**PLANNING BOARD SECOND MEETING OCTOBER 20 2020 4PM ZOOM AGENDA
CONDUCTED WITH ZOOM
OCTOBER 20, 2020 4:00 PM – TUESDAY**

1. APPLICATION #10-2020 SEPE 34 BROAD STREET

Broad Street 34, LLC
Preliminary & Final Major Site Plan
34, 36, 40, 44 Broad Street
Lots 25.01, 25.02, 26 and 27, Block 64

PROJECT NO. SEPE-00020
 DRAWING
 CD-2
 SHEET NO.
 7 OF 10

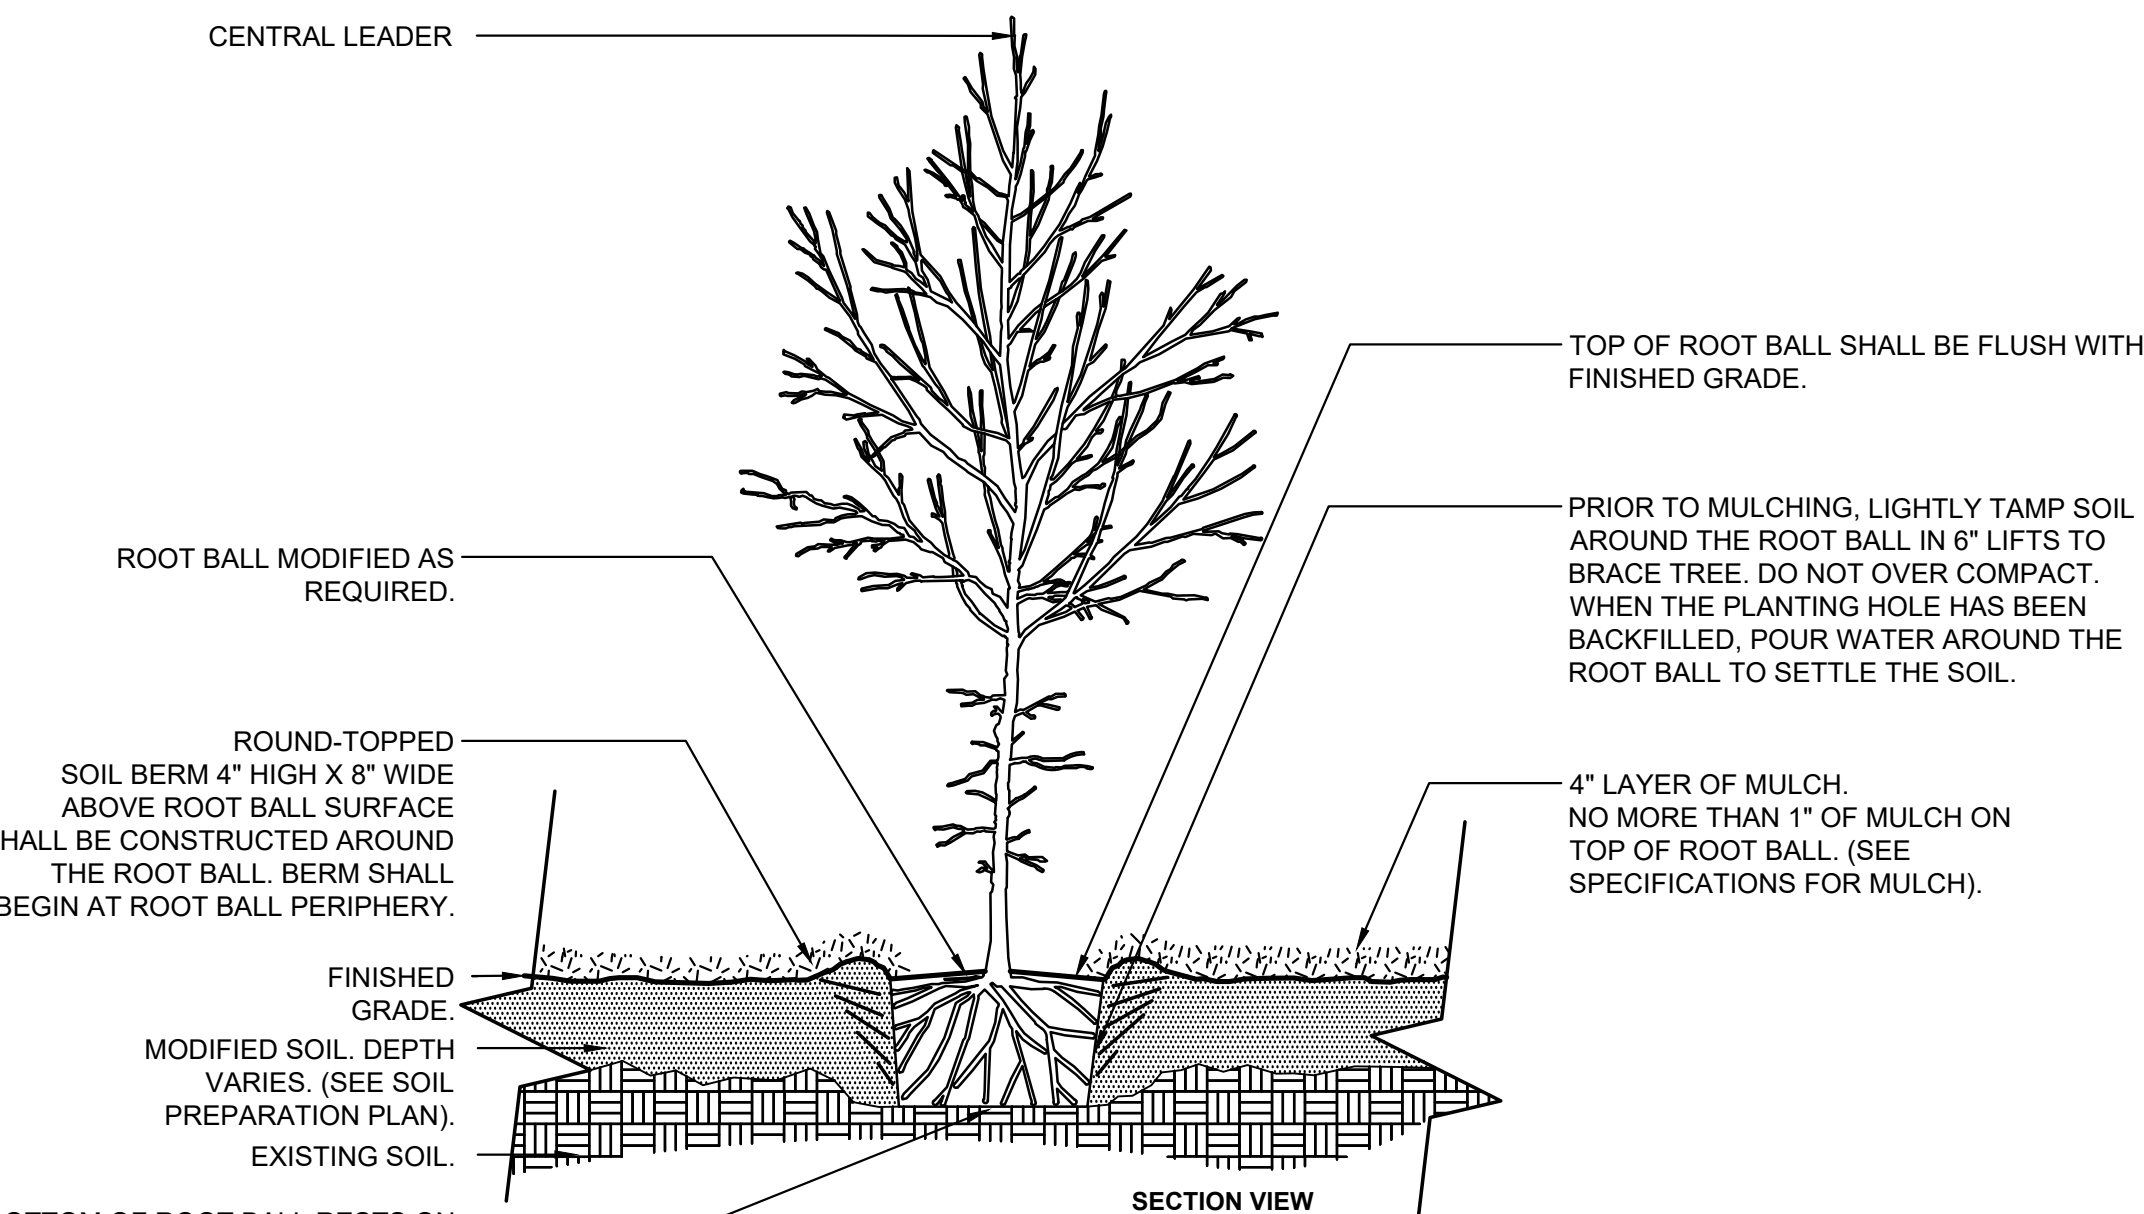
23. *A detail for the proposed freestanding light bases should be provided. **A freestanding light base detail has been added to the construction detail plan (sheet CD-2).***

25. *Details for the trash enclosure and gate must be provided. A trash enclosure detail has been added to construction detail plan (sheet CD-2).*
26. *The location of the proposed privacy fence shown in the details must be shown and labeled on the plan. The plan has been revised to show proposed privacy fence around the trash enclosure (sheet CD-1).*
